ADDENDUM NO. 3

GLENDALE HIGH SCHOOL AQUATICS CENTER GLENDALE UNIFIED SCHOOL DISTRICT

RESPONSES TO PRE-BID RFI'S

PB RFI-008

Reference Sheet SP1-1

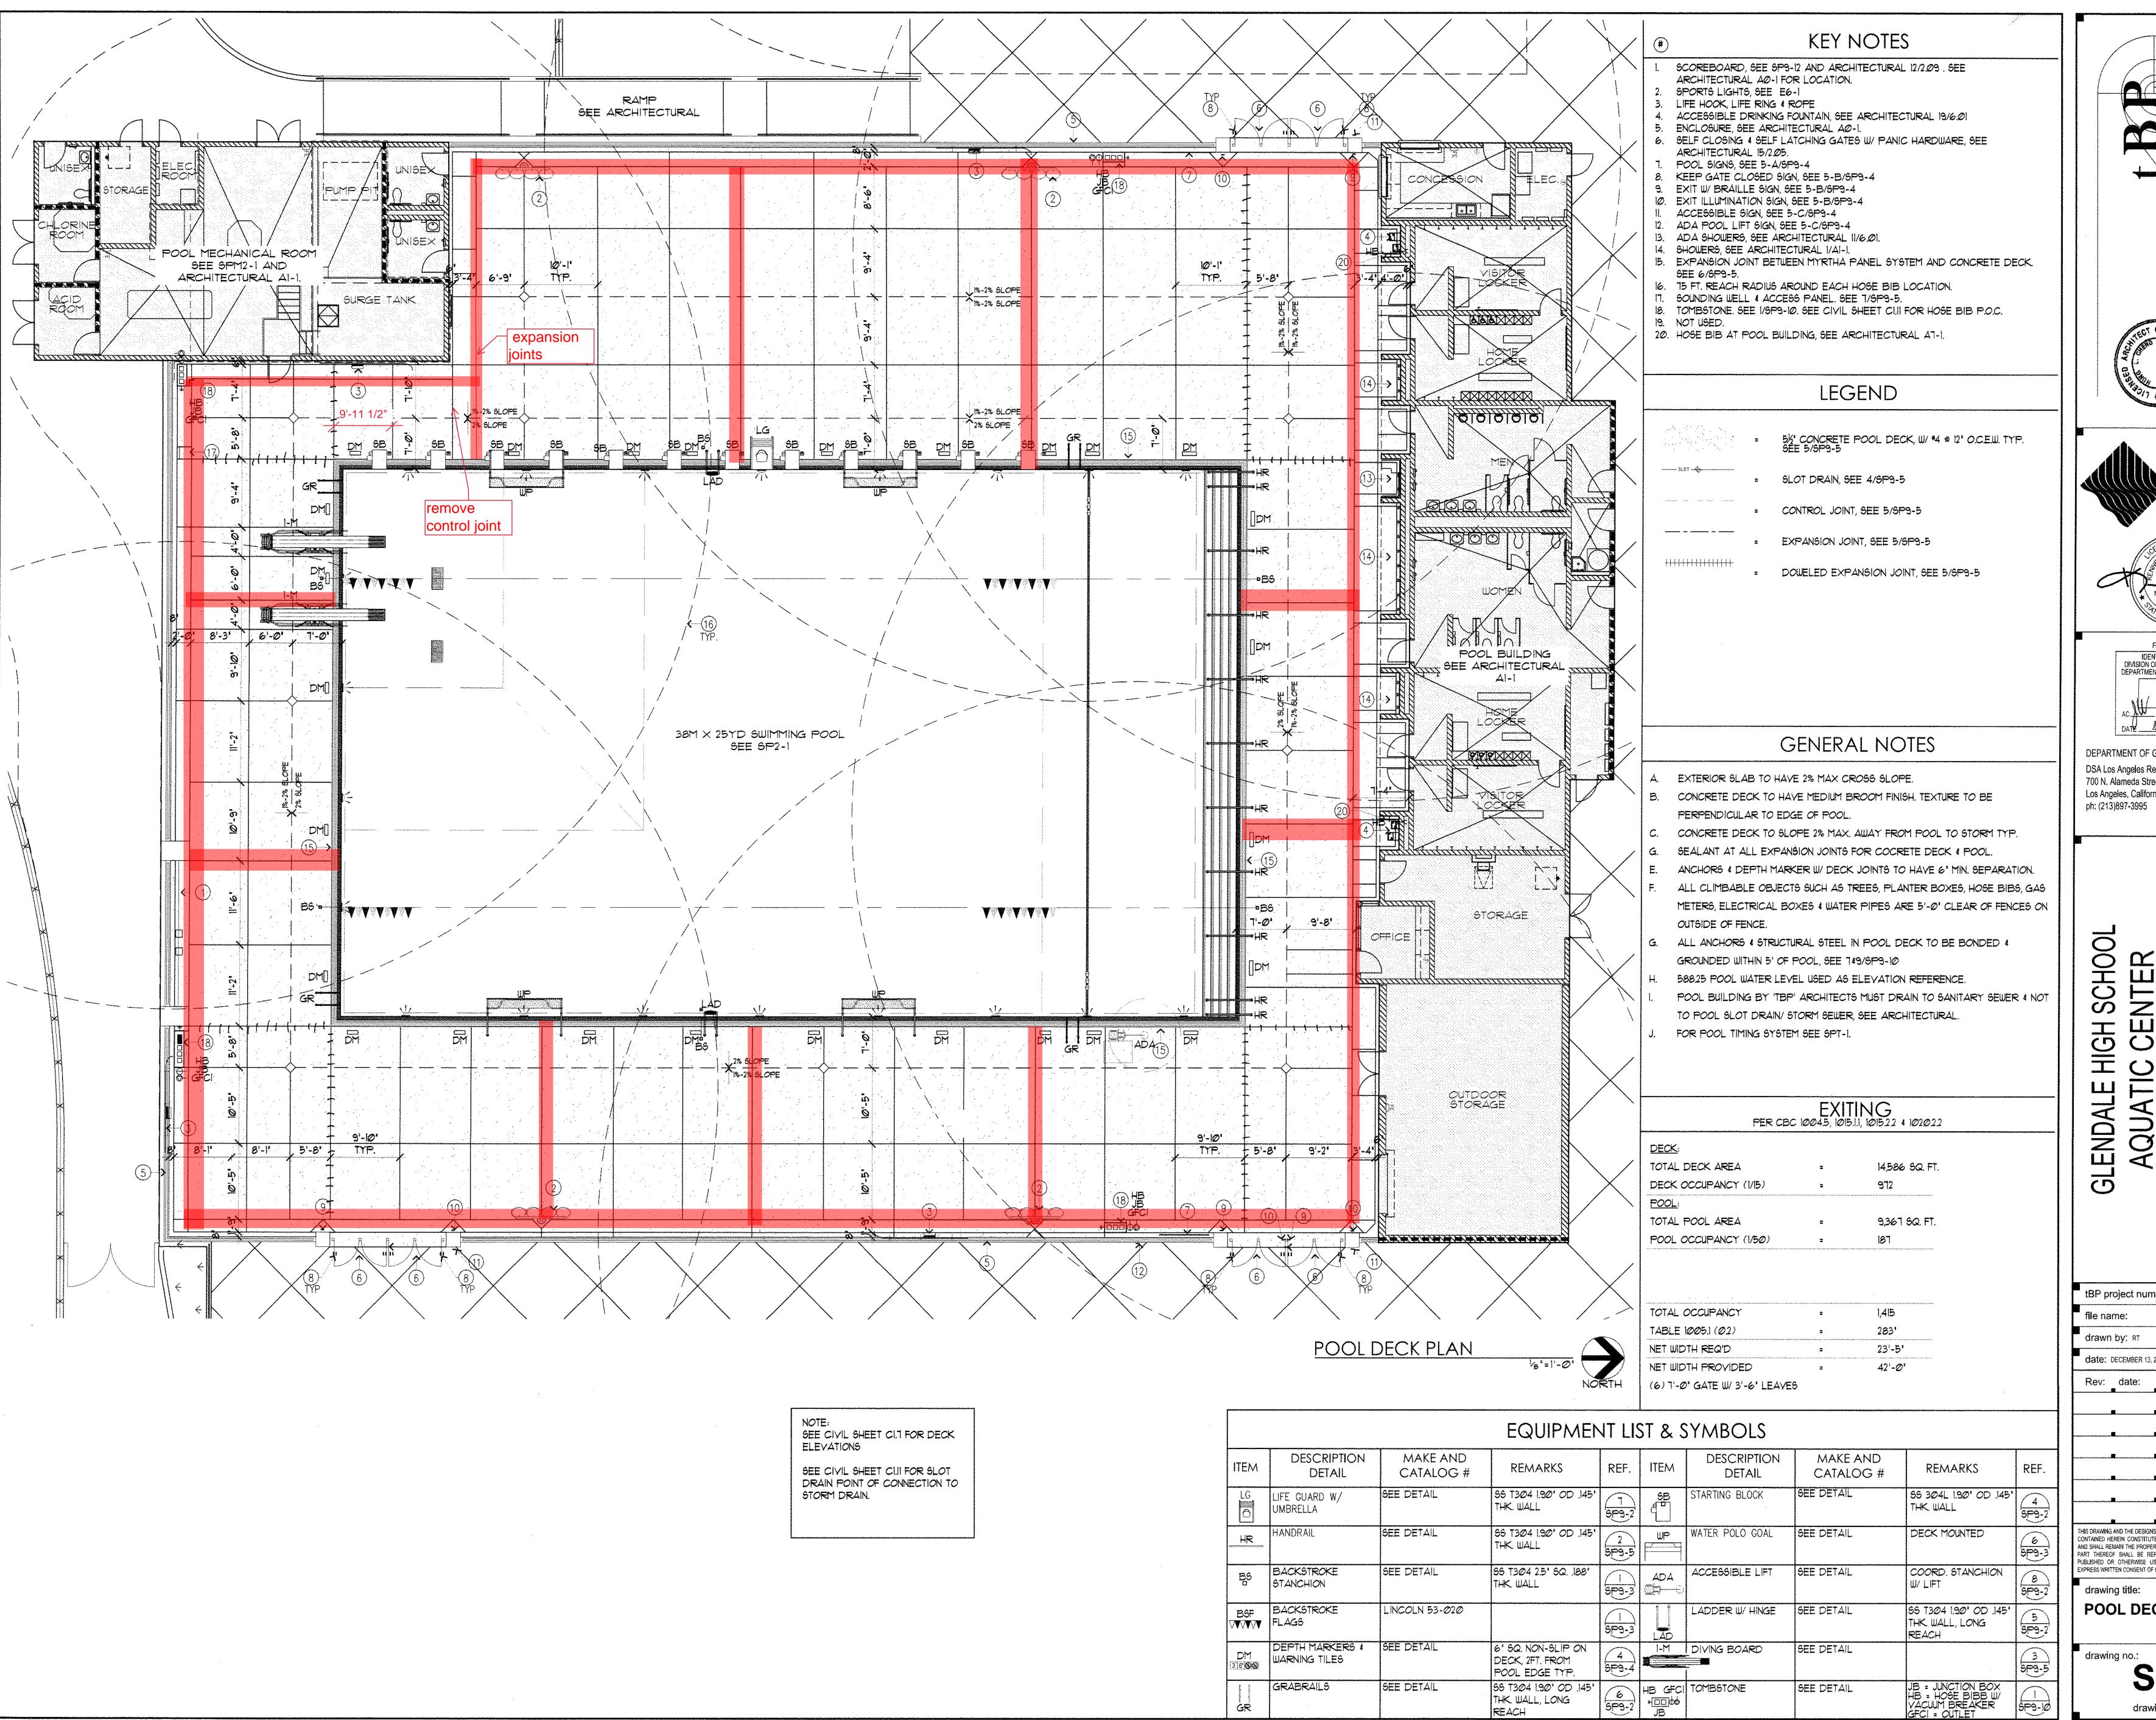
Sheet SP1-1 indicates doweled expansion joints in the concrete deck at each corner of the pool. These appear to be the only expansion joints indicated for the pool deck area. Is this correct?

Response – See attached plan showing location of expansion joints. Doweled expansion joints and control joints to remain unchanged.
